**LEVY COUNTY NUCLEAR POWER PLANT, UNITS 1 AND 2
DOCKET NOS. 52-029 AND 52-030
RESPONSE TO REQUEST FOR ADDITIONAL INFORMATION LETTER NO. 033 RELATED TO
STABILITY OF SUBSURFACE MATERIAL AND FOUNDATIONS**

Levy Nuclear Power Plant Units 1 and 2
Response to NRC Request for Additional Information Letter No. 033 Related to
SRP Section 2.5.4 for the Combined License Application, dated May 8, 2009

NRC RAI NUMBER: 02.05.04-23

**FIGURE RAI 02.05.04-23-1
LOCAL FRACTURE SYSTEMS MODELED IN FEM**

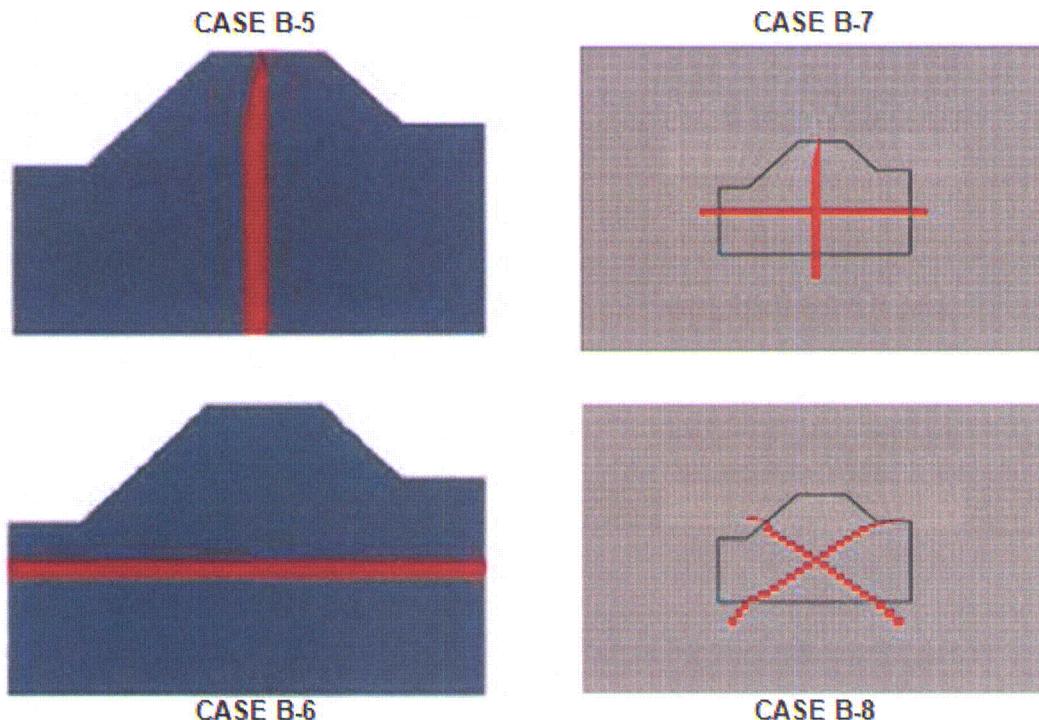
As shown in FSAR Figure 2.5.4.1-202 in the supplemental materials dated 12 September 2008 (Attachment 2), fracture spacing of these local fractures in both outcrops is 5.8m (19 ft) for the primary fractures trending N39W and 7.7m (23.5ft) for orthogonal fractures striking N51E. FSAR Section 2.5.4.1.2.1.3 (pg 2.5-191), supplemental materials (12 September 2008 Supplement, Attachment 2, pg 18, Site Uniformity Discussion), and RAI Response 2.5.4-2 address the assumptions made regarding the occurrence of large voids at depth directly beneath the RCC bridging mat to enable the 3D FEM analysis. However, it is not clear whether these assumptions properly incorporate pertinent information on the observed local fracture systems into the 3D FEM analysis, including the potential for enhanced dissolution at intersections of fractures with bedding planes. In addition, it is not clear whether field observations at the two outcrops in the site vicinity may have revealed more closely-spaced fracture systems that should be included in the 3D model, and whether the fractures observed in the two outcrops are expected to be characteristic of the anticipated fracture sets at the site location so that the 3D model is appropriate for the site location.

In order for the staff to thoroughly assess the input data for and results of the 3D FEM analysis, please explain how information related to the observed local fracture systems was incorporated into this analysis for the Levy LNP1 and LNP2 sites, including possible interactions between fractures and intersecting bedding planes which may have a strong influence on development of dissolution voids at depth. To ensure that the 3D FEM model is appropriate for the site location, please clarify whether more closely-spaced fractures also occur in the two outcrops and whether the fractures observed in the two outcrops are thought to be characteristic of fracture sets at the site location. Please explain how the design analyses account for settlement due to movement permitted by joint sets and bedding planes.

The observed local fracture systems were analyzed in the finite element model through sensitivity analyses that considered the presence of these fractures. These fractures were modeled as 10-feet wide voids present beneath the entire nuclear island, as such:

- Case B-5 - 10-feet wide void at approximate trend of N39W
- Case B-6 - 10-feet wide void at approximate trend of N51E
- Case B-7 - 10-feet wide voids in both approximate trends of N39W and N51E
- Case B-8 - 10-feet wide voids in both approximate trends of N-S and E-W

These cases are illustrated below on Figure RAI 02.05.04-23-1:

By modeling these fractures as 10 feet wide, the analyses account for fractures that are two orders of magnitude larger than those encountered during the Grout Test Program. These fractures were also conservatively modeled immediately beneath the RCC bridging mat. Also, by placing these fractures in the center of the nuclear island, larger stresses on the RCC bridging mat are induced. The combination of these assumptions represent that up to one hundred fractures of 0.1-foot width, in each direction, are modeled together in the center of the footprint, immediately beneath the RCC bridging mat.

The maximum tensile stresses induced in the four cases (B-5 through B-8) are 102 psi, 94 psi, 112 psi, and 126 psi, respectively. The maximum elastic settlement was determined to be 0.27 inches, with differential settlement of 0.17 inches. These results are considerably less than the ultimate tensile capacity of the RCC bridging mat, and considerably less than the allowable settlement identified in the AP1000 DCD Rev. 17.
